1930

BOREN AVENUE

VBOB LLC | LMN | WEISMAN DESIGN GROUP
DESIGN REVIEW | SDCI PROJECT # 3031389-LU | FEBRUARY 19, 2018

ELEVATION AT LOT LINE

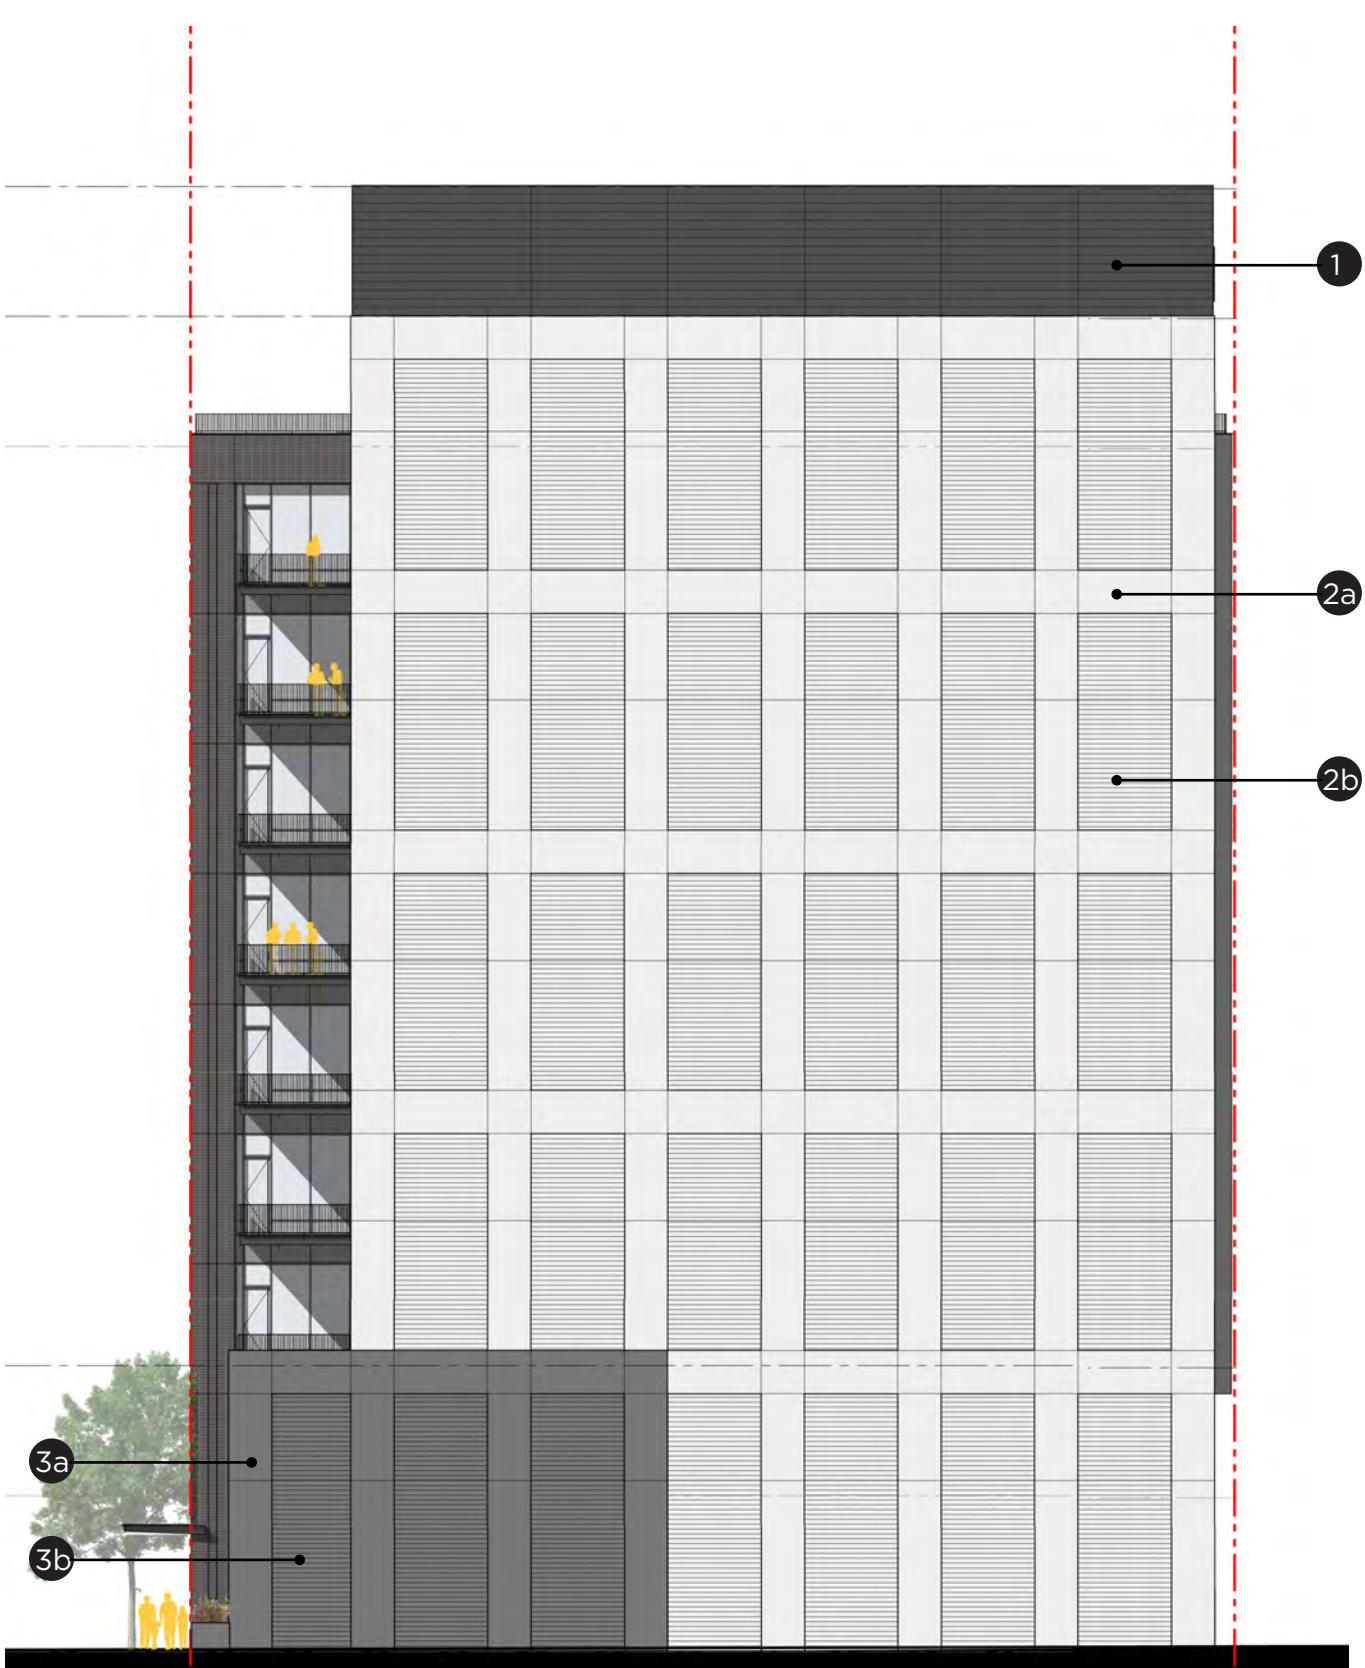
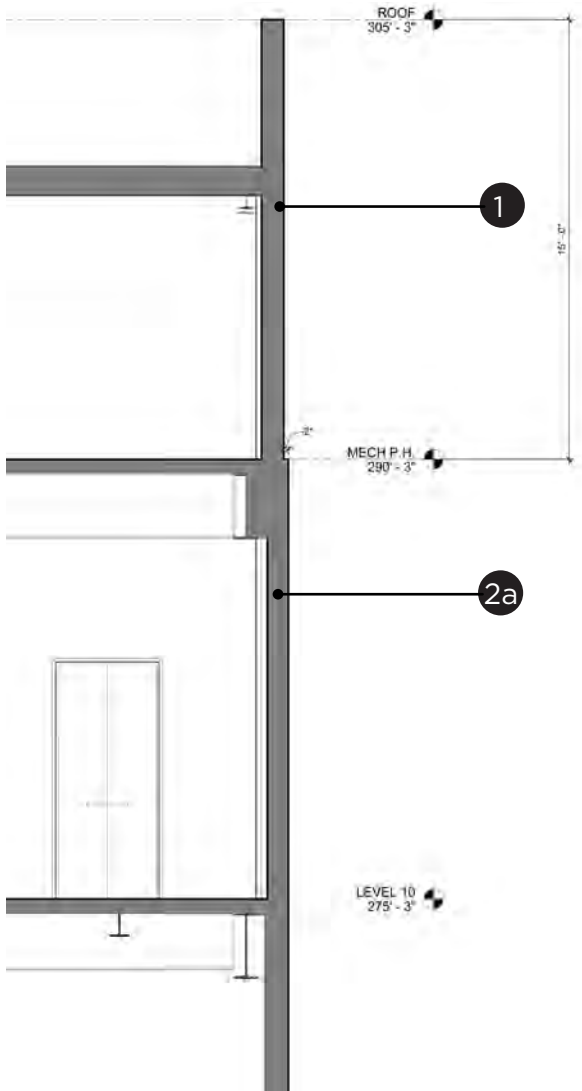
1A - Building terminus. Though the Board supported the building's off-set core which created a successful building terminus and worked well with the adjacent building; there was some concern that the building's rigid massing form was diminished by the flush condition of the penthouse along the zero-lot-line edge. At the next meeting the Board would like to see details related to the material transition from the square form to penthouse along this edge. (A2.2. Rooftop Mechanical Equipment; B4 Design a Well-Proportioned & Unified Building)

The elevator hoistways in the core along the lot line limit the ability to offset the penthouse from the mass below. To address the boards concern the team has proposed changing the building material at the penthouse from precast concrete to metal panel. The change in material, color and pattern will create a visual break from the rigid massing form below as it wraps around to Boren Ave. and the Alley.

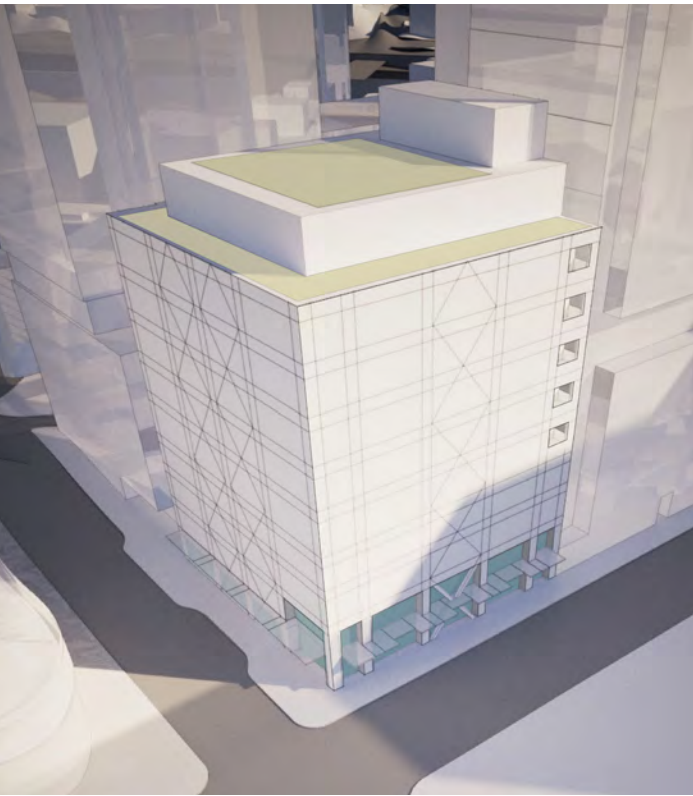
1B - The Box. The Board unanimously supported the simple form, regular rhythm, and rigor established by the loft-style proportions of the proposed design concept. In addition, the Board appreciated the grid pattern and slight variation along Boren and Virginia Avenue. (B4 Design a Well-Proportioned & Unified Building)

The form and rhythm of the design has been maintained with further refinement to the window bay spacing to establish more rigor along Boren Avenue.

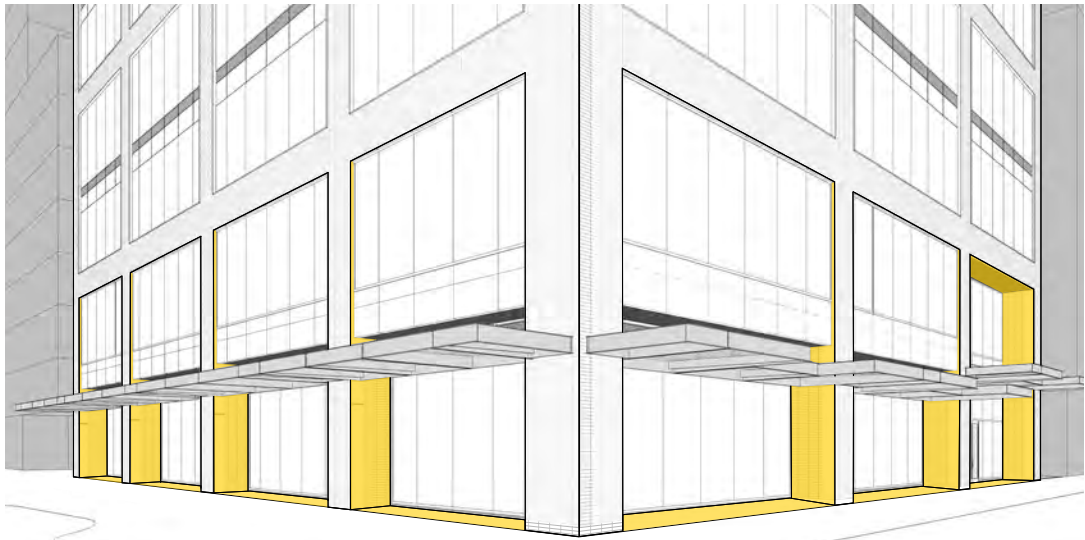
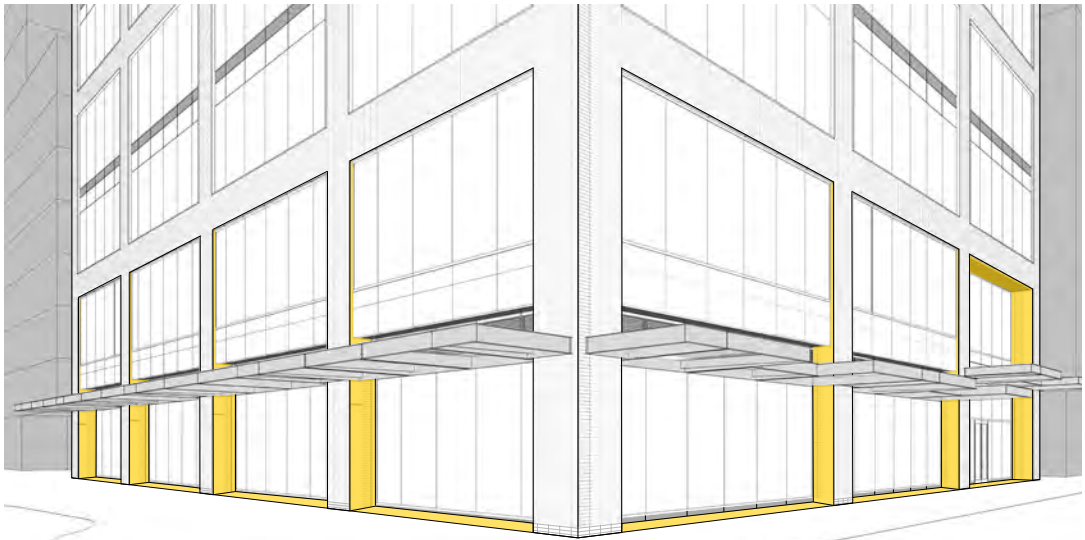
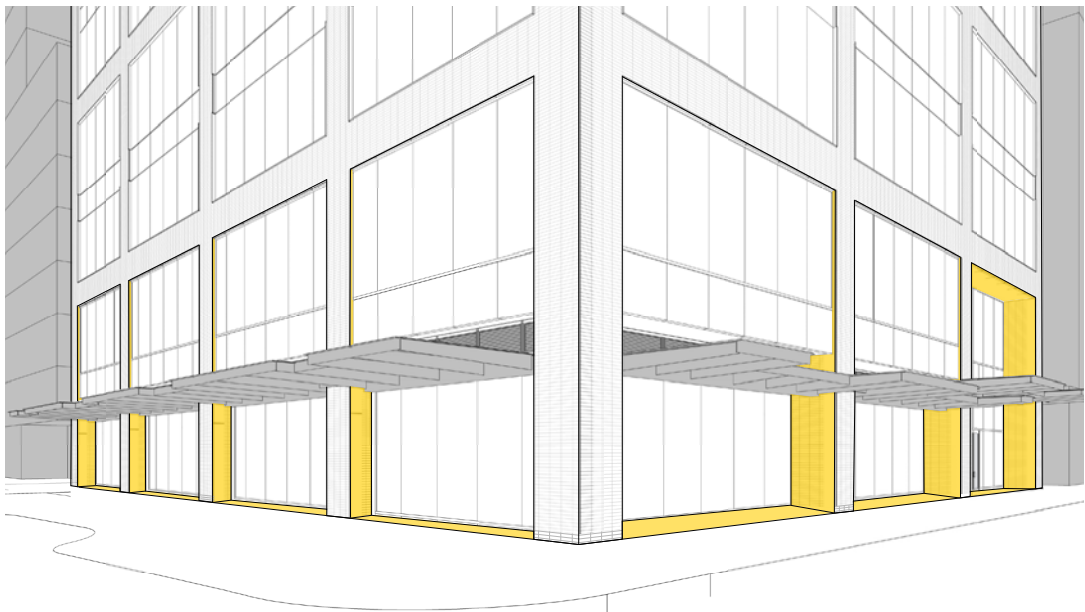
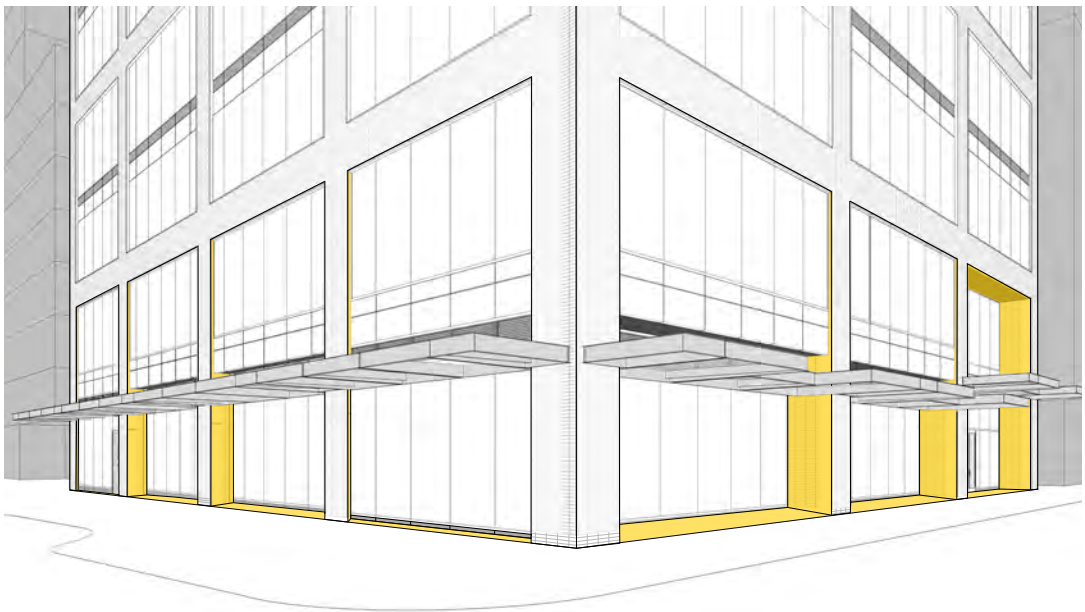
1C - However, the Board agreed the base (first two-stories) needed further refinement with the goal of reinforcing the rigor and geometry established by the upper stories. The Board would like to see additional studies of the undercut, specifically with the following options: (B4 Design a Well-Proportioned & Unified Building, C1.3. Street-Level Articulation for Pedestrian Activity):

- i.** Recess the entire base expression
- ii.** Recess the entire base consistently for half the amount of depth
- iii.** Recess across the Virginia Street façade consistently, with a lesser depth
- iv.** Recess at the entry point along Virginia (at the center), which could also improve the legibility of the entry point along this street and enhance the symmetry.
- v.** The Board acknowledged that the design resolution of the undercut may result in a departure request related to minimum commercial depth along Virginia Street. The Board stated they would be open to such a departure if this resulted in the best solution, however studies would need to be provided.

Option i - Recess the entire base expression (4'-6")
**Does not meet Street Level Use depth requirements along Virginia St.*

Option ii - Recess the entire base for half the amount of depth (2'-1")
**Requires a canopy departure for depth of canopy along Boren Avenue.*

Option iii - (Preferred) Recess Virginia St. facade consistently with a lesser depth. Boren Avenue (4'-6") Virginia Street (2'-1")

Option iv - Recess middle bays along Virginia St. further (4'-6")
**Does not meet Street Level Use depth requirements along Virginia St.*

DRB - BOREN ELEVATION

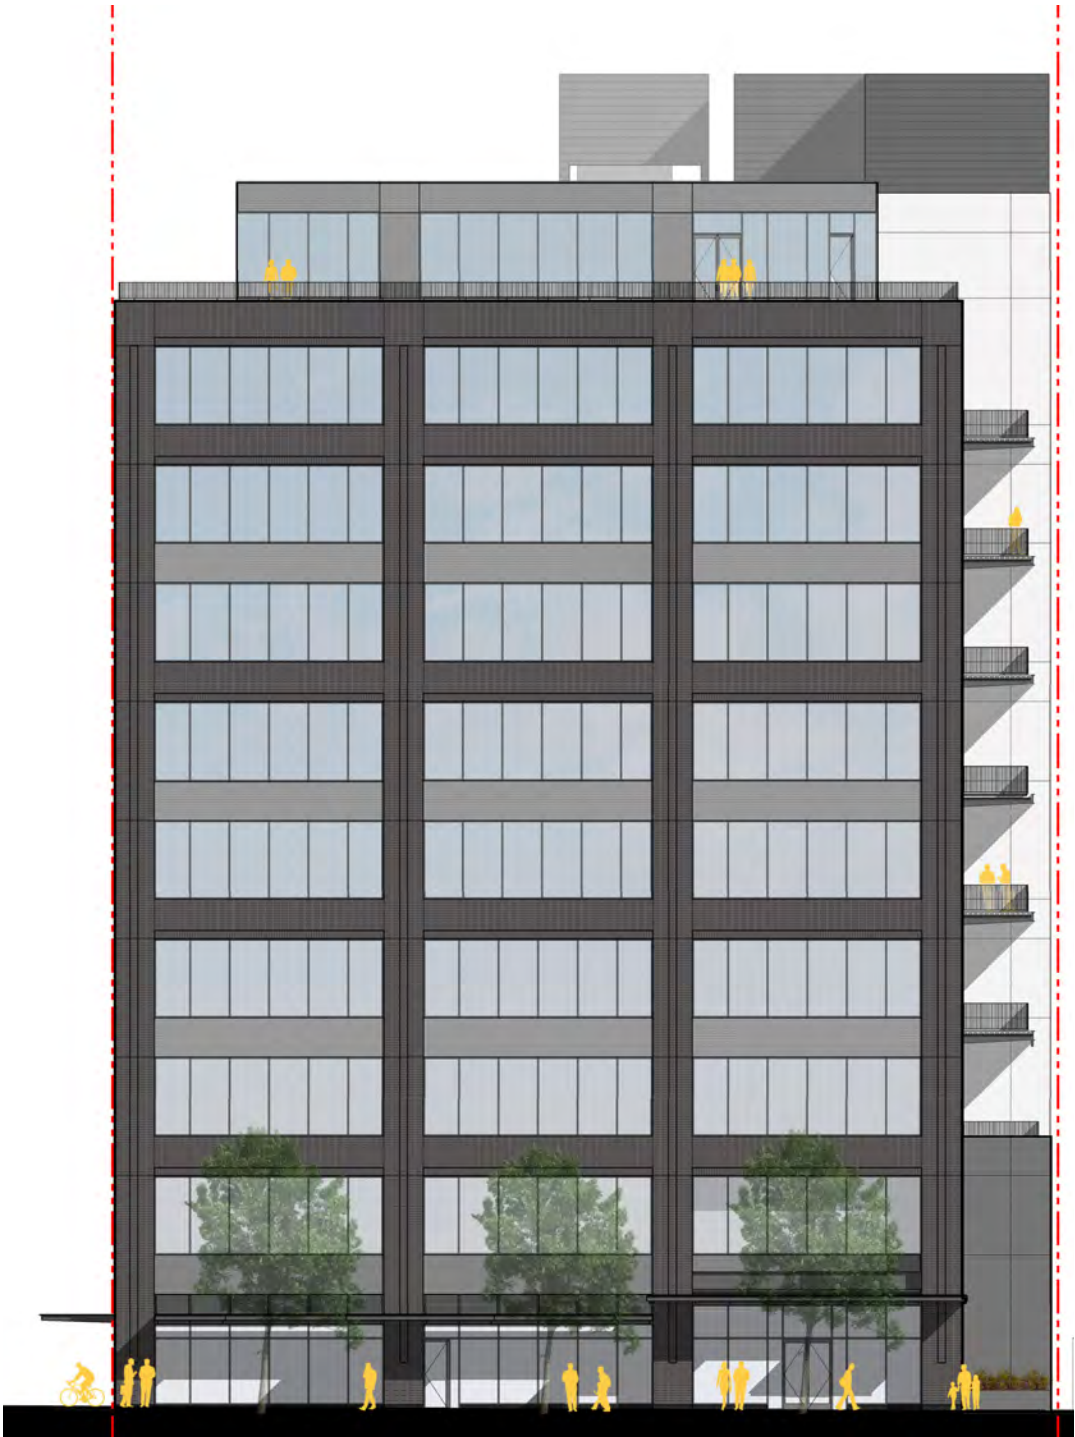
1E - The Board discussed the proposed balconies, commenting that further refinement was needed to integrate the balconies. The Board requested the design team refine the balcony at the proposed location, study alternative balcony locations, or potentially remove the balconies altogether. (B4 Design a Well-Proportioned & Unified Building)

The balconies have remained in their original location to help keep the rigidity of the massing form at the corner of Boren Ave. and Virginia St. In discussions with the neighbor to the south this is the preferred location for the balconies as it provides relief for the adjacent residential tower. To address the board's concern the design team has refined the Boren Ave. facade to have three equal bays. The steel balconies are set back from the Boren Ave. facade to allow the brick piers to terminate and complete the massing form.

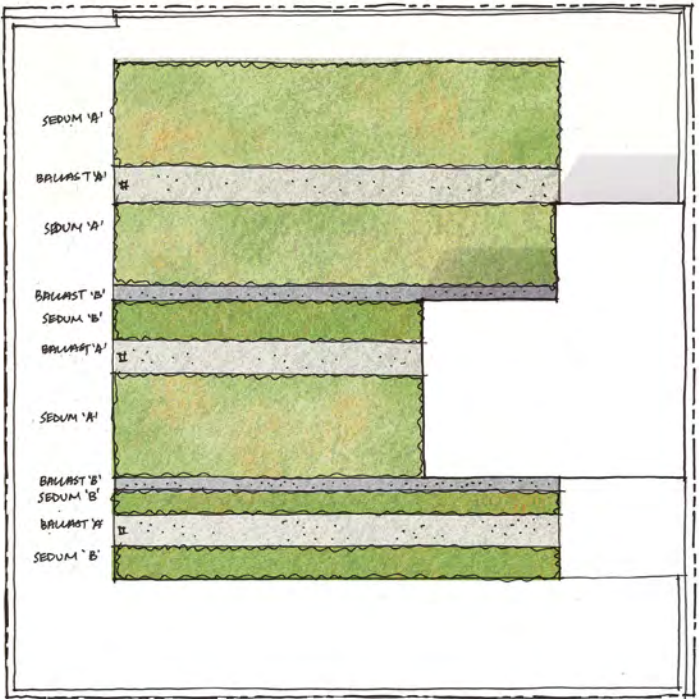
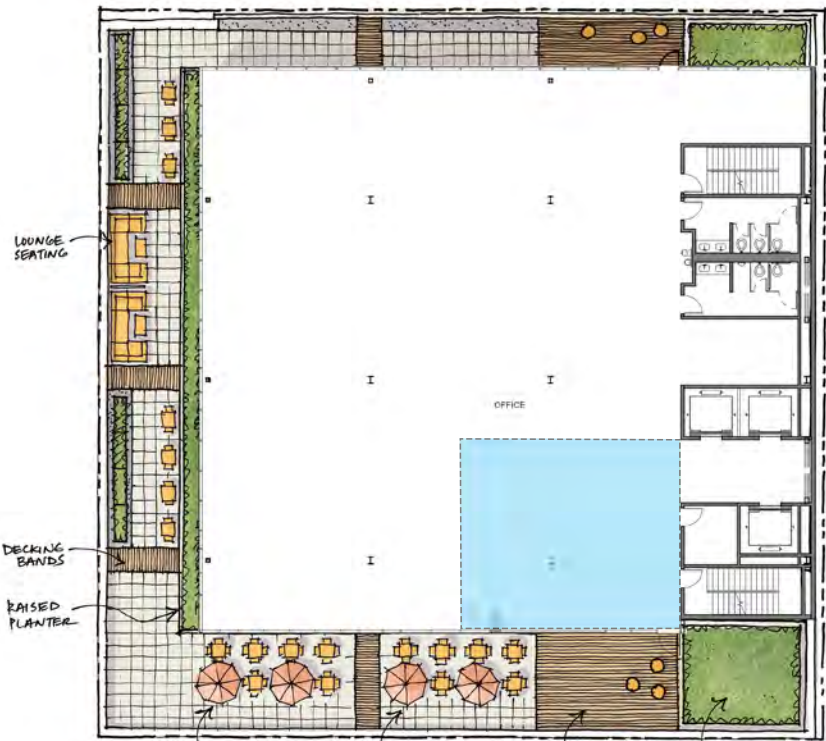
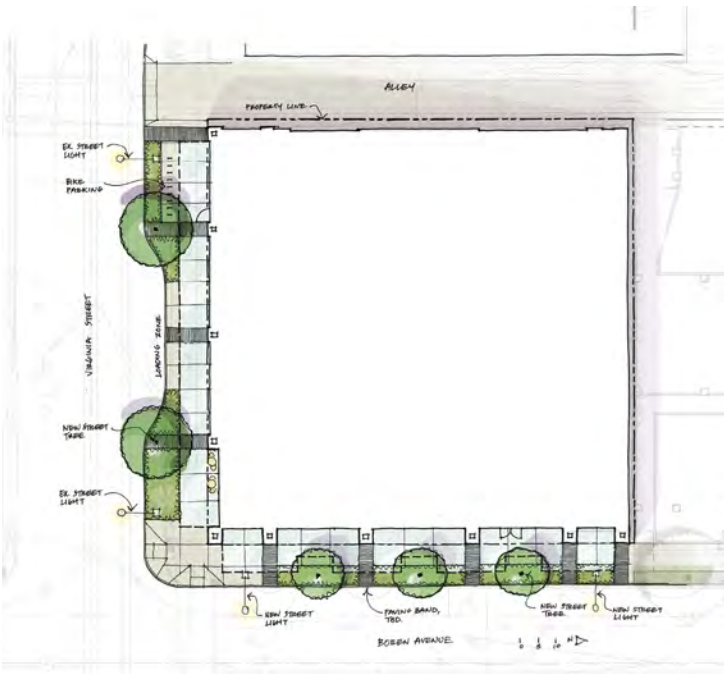
2A - The Board supported the proposed green roof and conceptual roof deck plan which provided a thoughtful response to this highly visible façade. (D2 Enhance the Building with Landscaping)

RESPONSE
The level 10 roof deck design remains the same with minor updates to accommodate massing changes and maintenance access.
